SOUTH VALLEY WATER RECLAMATION FACILITY
PROJECT 4D
WEST JORDAN, UTAH

MECHANICAL
BIOREACTOR NO. 4 AIR
DIFFUSER SYSTEM PLAN

SOUTH VALLEY WATER RECLAMATION FACILITY		
WEST JORDAN UTAH		
THIS DRAWING IS THE PROPERTY OF SANITAIRE AND IS SUBMITTED IN CONFIDENCE. IT IS NOT TO BE REPRODUCED, COPIED OR DUPLICATED WITHOUT PERMISSION OF SANITAIRE.		
BIOREACTOR 1-4 STRUCTURAL, DROPLEGS & MANIFOLDS KEY PLAN		
ITT Corporation		
SANITAIRE® BROWN DEER, WISCONSIN 53223 ABJ®		
DRAWN BY: MRL	DATE: 12-4-07	DESIGN: NEW/REV
CHKD BY: MTR	DATE: 12-12-07	STD.
APPROV BY: DE	DATE: 12-13-07	SHEET: 2 OF 40
JOB: 07-67425		
S-2

BIOREACTOR 1-4
AERATION GRIDS
KEY PLAN

OX-6A
GRID TYPE 7
PLAN VIEW (29)

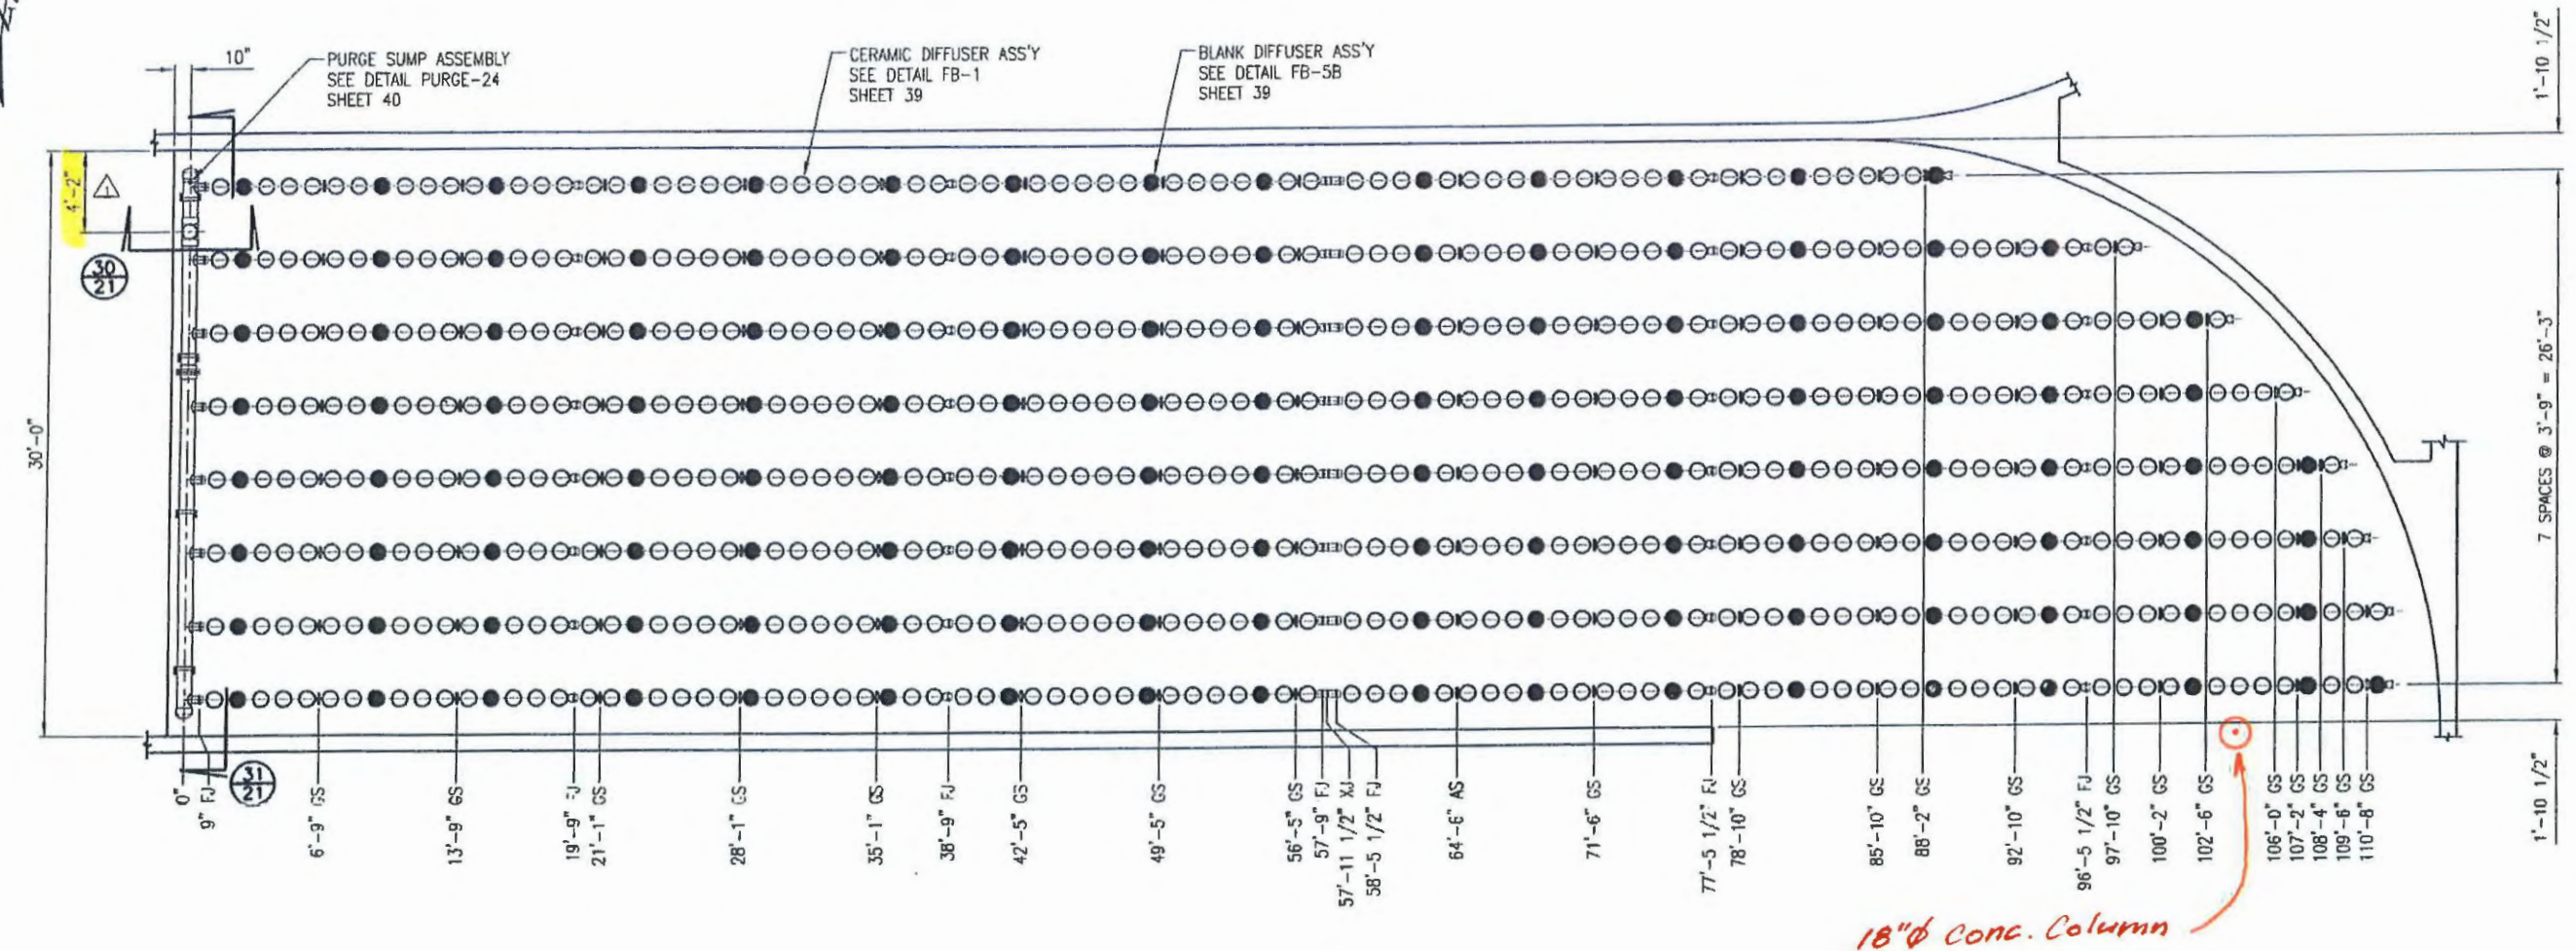
FOR THIS GRID:
REMOVE AND REPLACE ALL CERAMIC DIFFUSERS WITH EPDM MEMBRANE
DIFFUSERS AND PVC SUBPLATES. TYPICAL BOTH BIOREACTORS.

OX-6B
GRID TYPE 8
PLAN VIEW 32

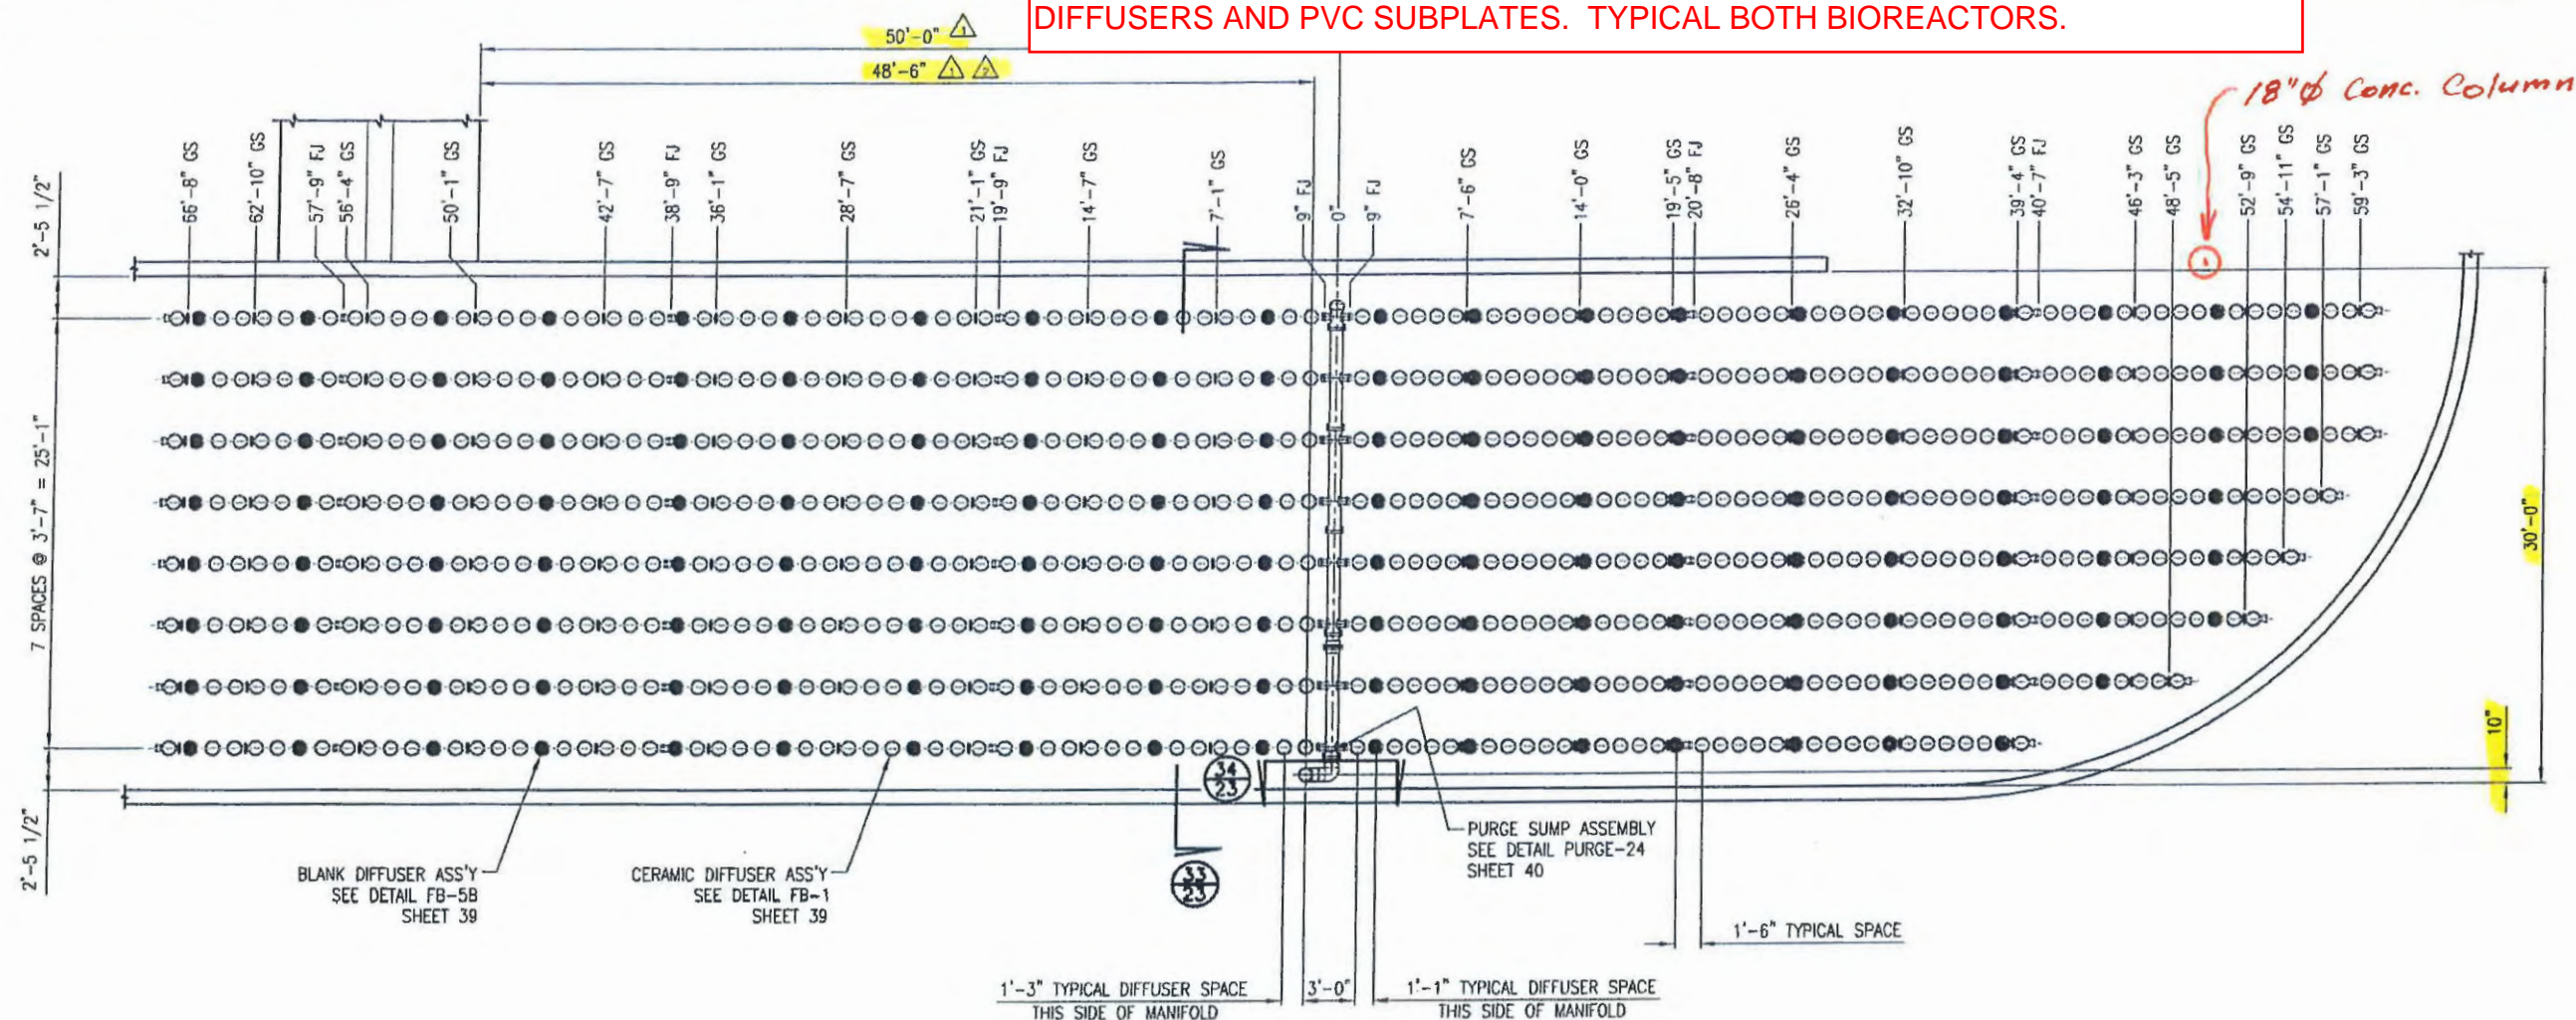
FOR THIS GRID:
REMOVE AND REPLACE ALL CERAMIC DIFFUSERS WITH EPDM MEMBRANE
DIFFUSERS AND PVC SUBPLATES. TYPICAL BOTH BIOREACTORS.

OX-6B
GRID TYPE 9
PLAN VIEW (36)
(2) BIOREACTORS 1 & 4 - REQ'D AS SHOWN
(2) BIOREACTORS 2 & 3 - REQ'D MIRROR IMAGE

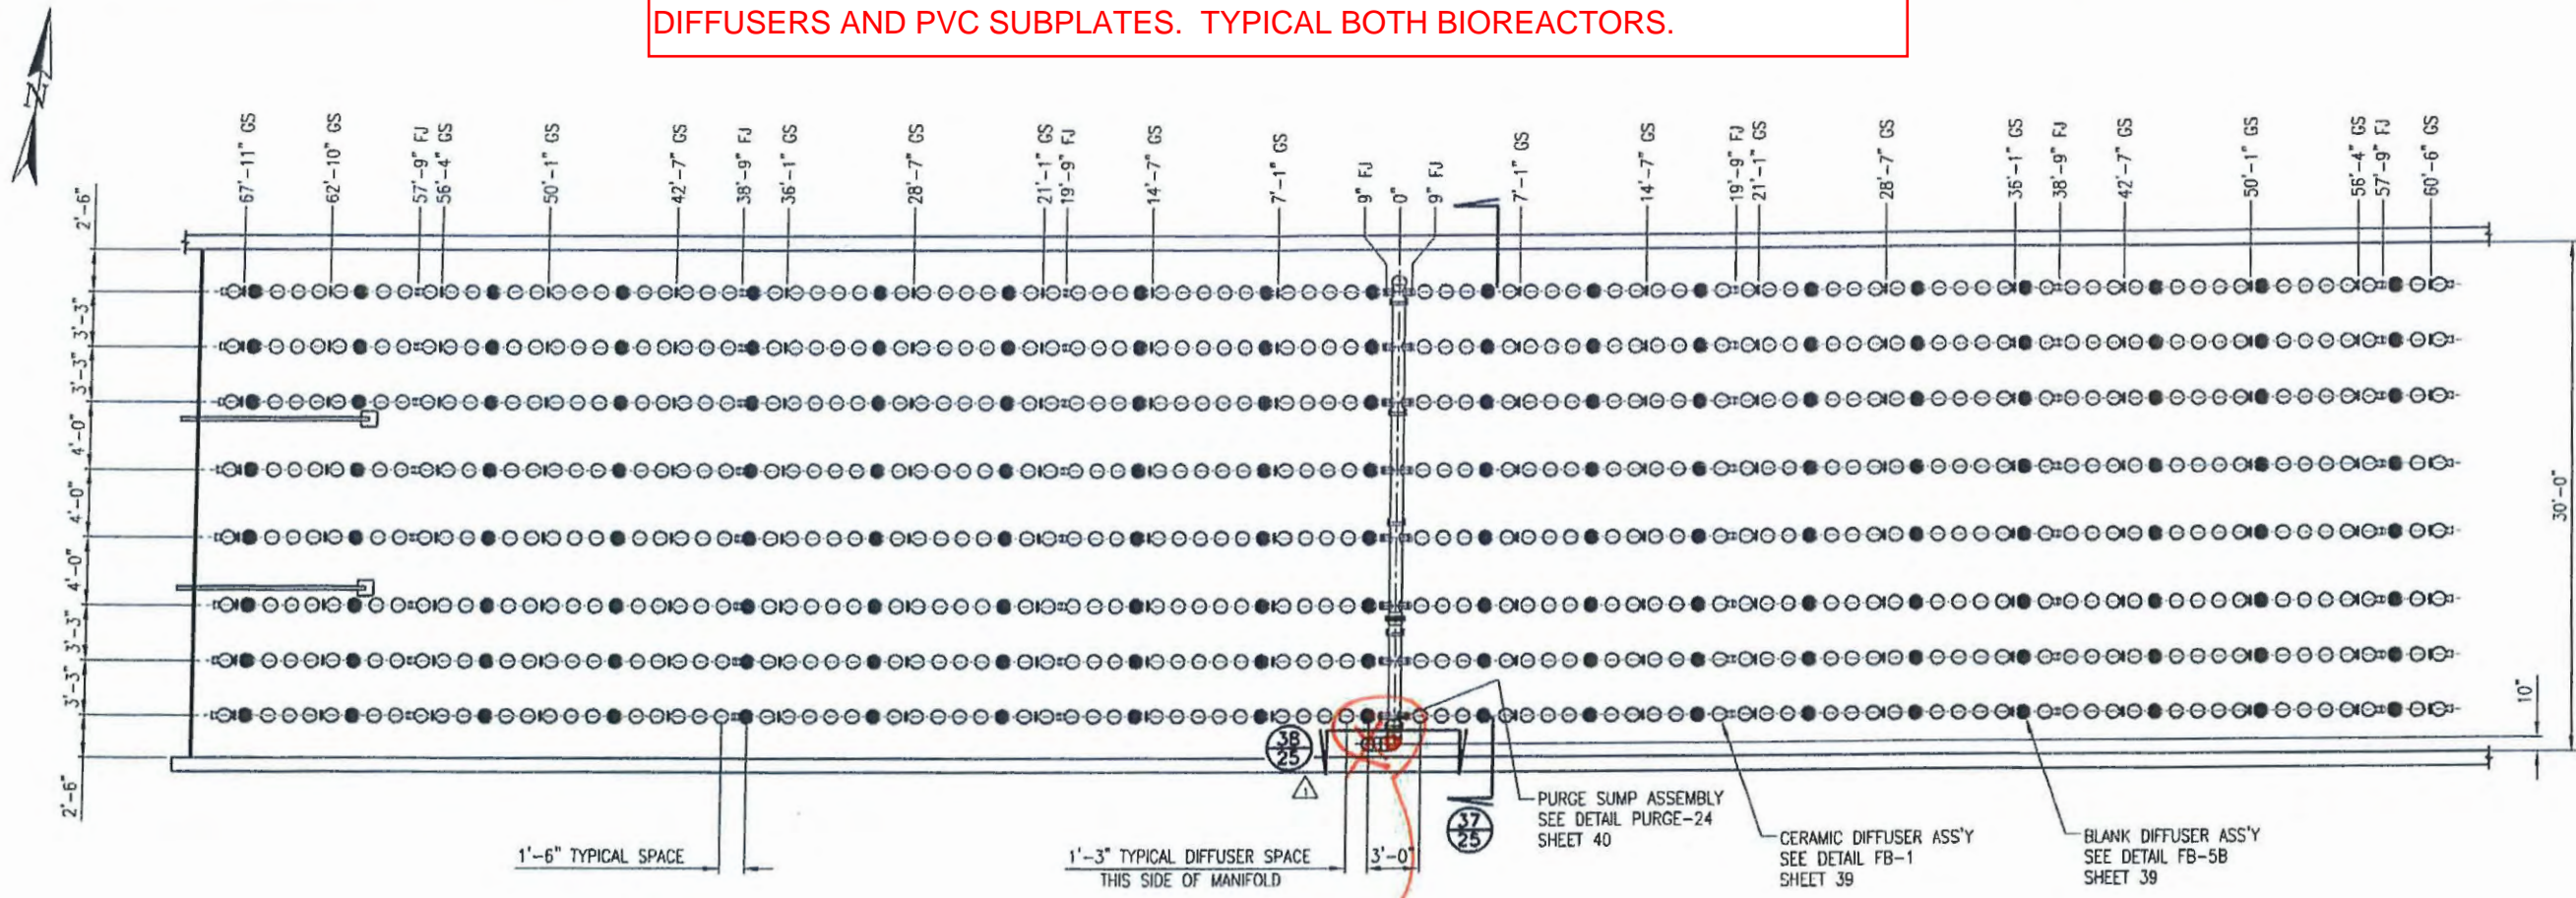
FOR THIS GRID:
REMOVE AND REPLACE ALL CERAMIC DIFFUSERS WITH EPDM MEMBRANE
DIFFUSERS AND PVC SUBPLATES. TYPICAL BOTH BIOREACTORS.

GRID TYPE 10
PLAN VIEW 39

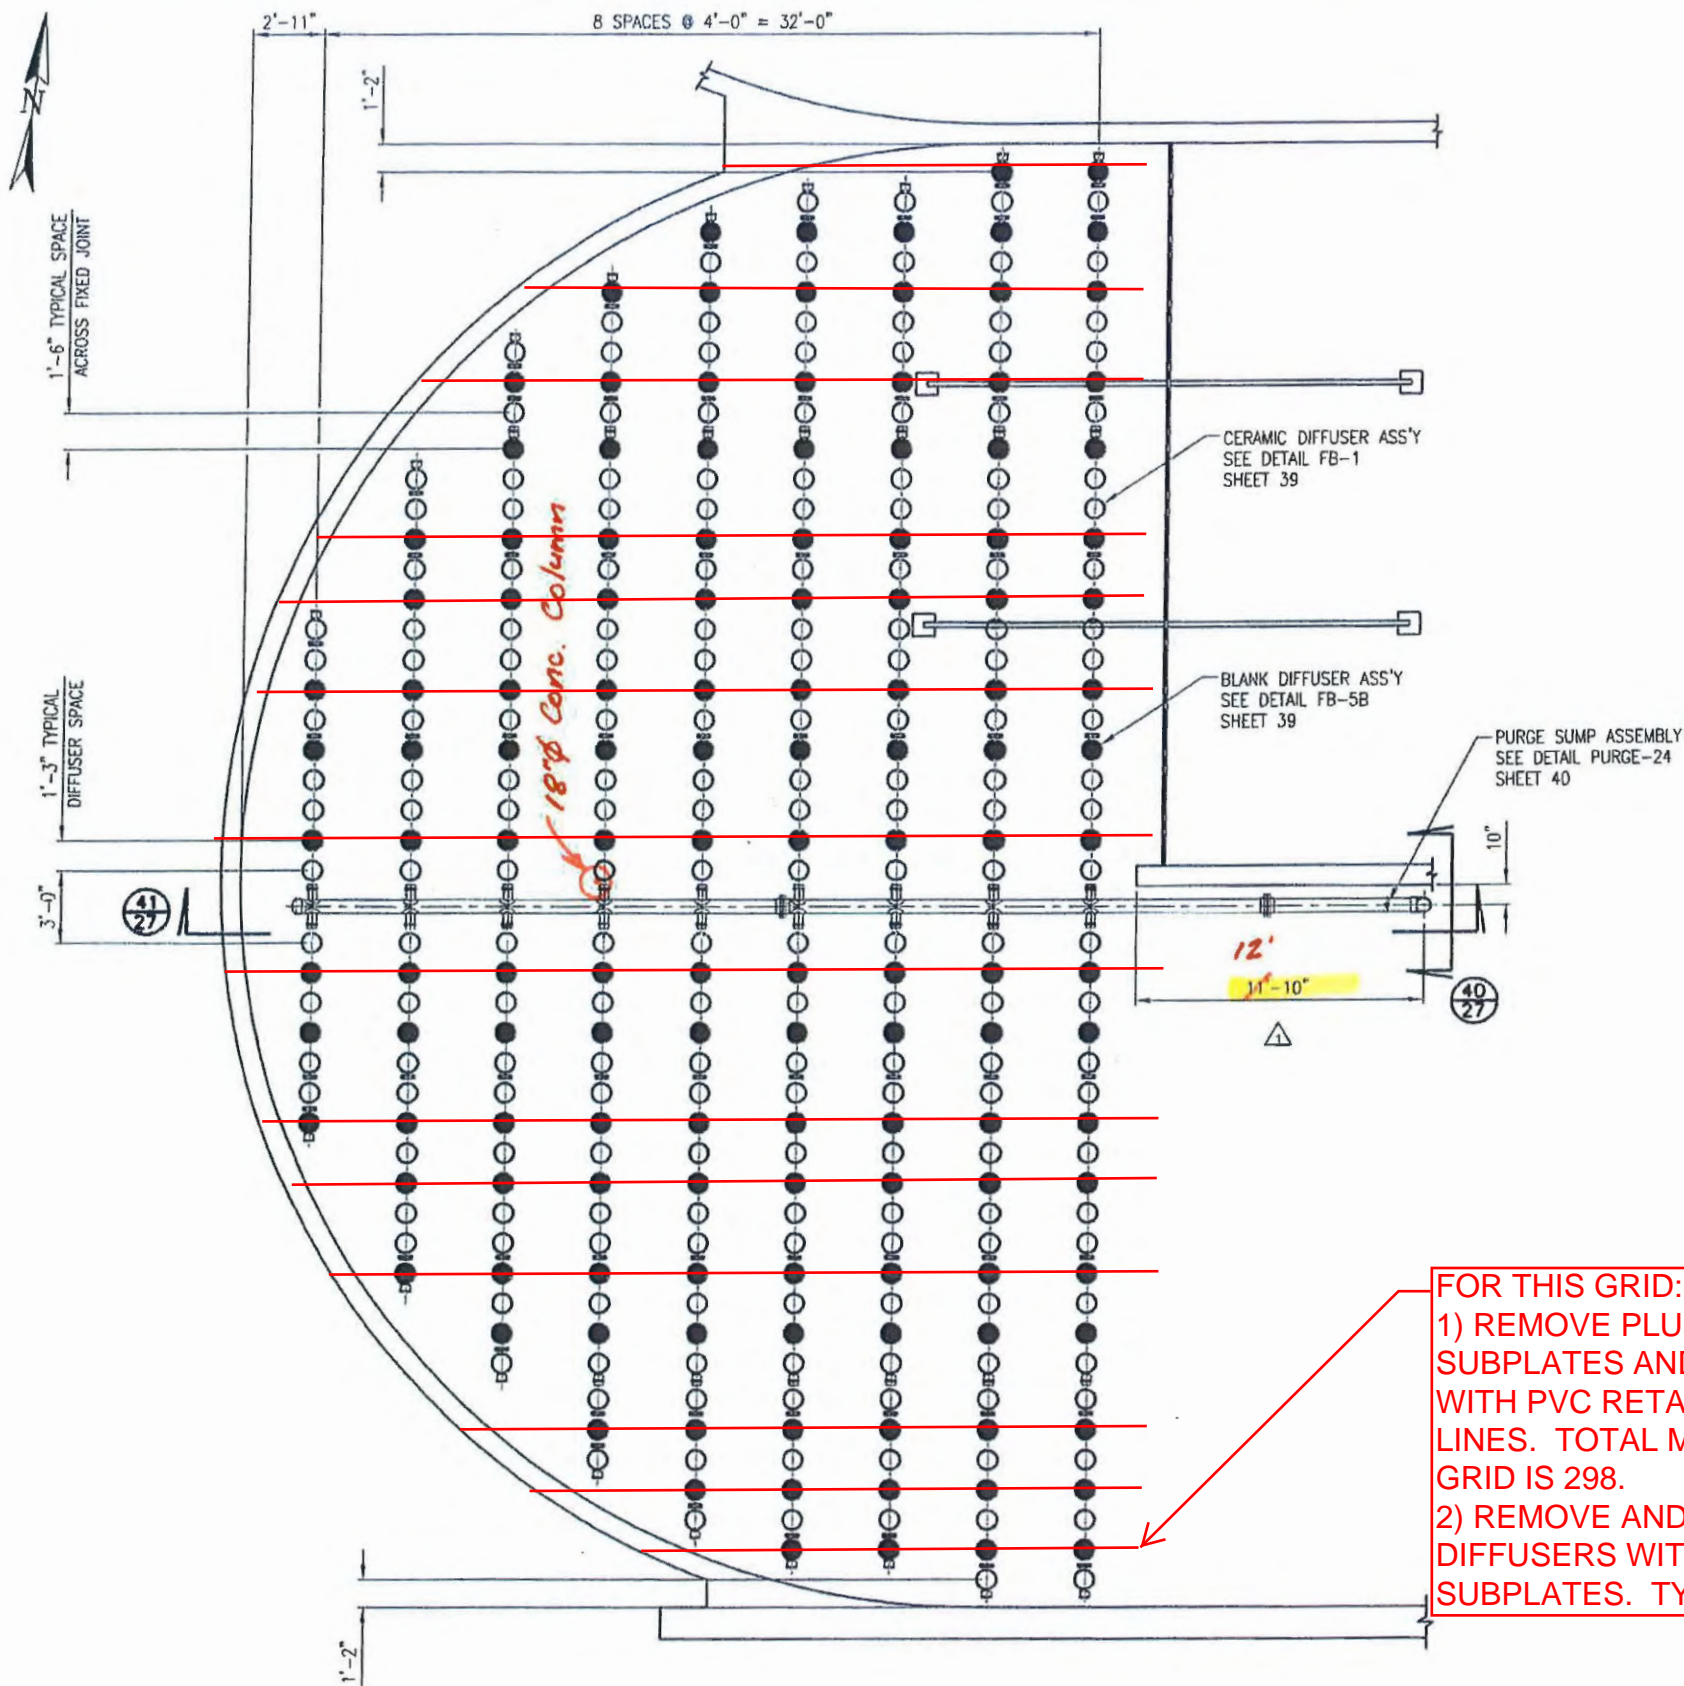
FOR THIS GRID:
1) REMOVE PLUGS IN ORIFICES, INSTALL PVC SUBPLATES AND ADD 98 EPDM MEMBRANE DIFFUSERS WITH PVC RETAINER RINGS WHERE INDICATED BY RED LINES. TOTAL MEMBRANE DIFFUSER COUNT IN THIS GRID IS 298.
2) REMOVE AND REPLACE ALL OTHER CERAMIC DIFFUSERS WITH EPDM MEMBRANE DIFFUSER AND PVC SUBPLATES. TYPICAL BOTH BIOREACTORS.
